IN THE MATTER OF THE
APPLICATION OF IDAHO POWER
COMPANY TO UPDATE ITS WIND
INTEGRATION RATES AND
CHARGES.

) Case No. IPC-E-13-22
) SUPPLEMENTARY COMMENTS
) OF AWEA AND
) RENEWABLE NORTHWEST
)

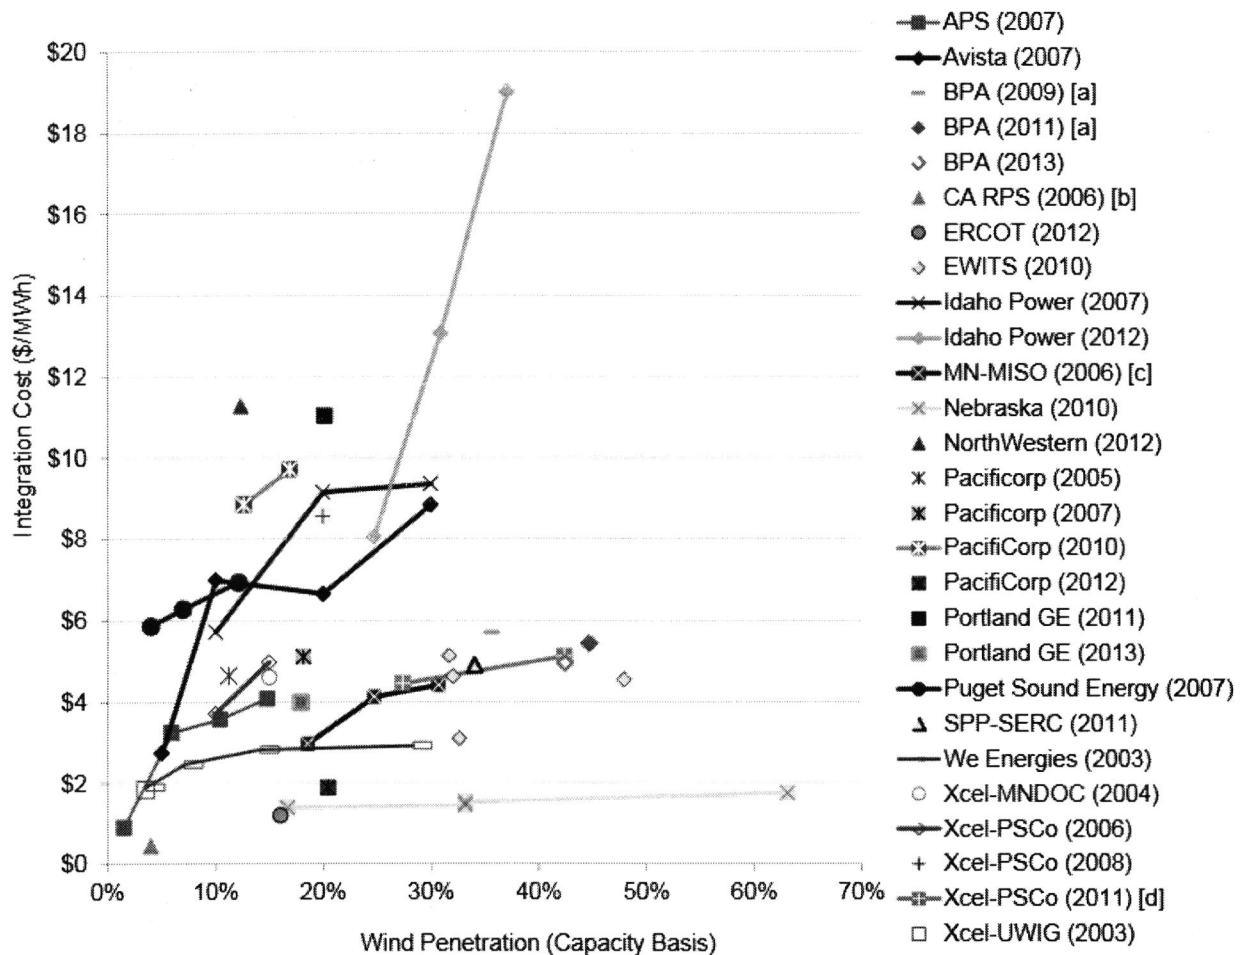
As discussed here and in our July 2, 2014 comments in this proceeding, the Company's 2013 Study contains significant methodological flaws. The primary shortcomings of the 2013 Study are that it (1) uses the day-ahead wind forecast error instead of the hour-ahead forecast error in calculating the reserve requirement for wind; and (2) calculates reserve requirements based on the outdated assumption that reserves balance wind variability on a stand-alone basis instead of the standard operating practice of balancing the deviations of net load (load minus wind and other generation).

In response to our opening comments identifying the methodological flaws in the 2013 Study, Idaho Power's Reply Comments claim that the universal statistical and economic principles that underlie wind integration studies for other areas do not apply to Idaho Power.⁹ We disagree. While any utility's unique circumstances must be considered when designing a wind integration study, those circumstances do not change the fundamental principles of statistics and utility economics. As illustrated in the following chart, Idaho Power's proposed reserve needs and wind integration costs are extreme outliers across all utilities, even among other power systems in the unorganized, bilateral markets of the West:¹⁰
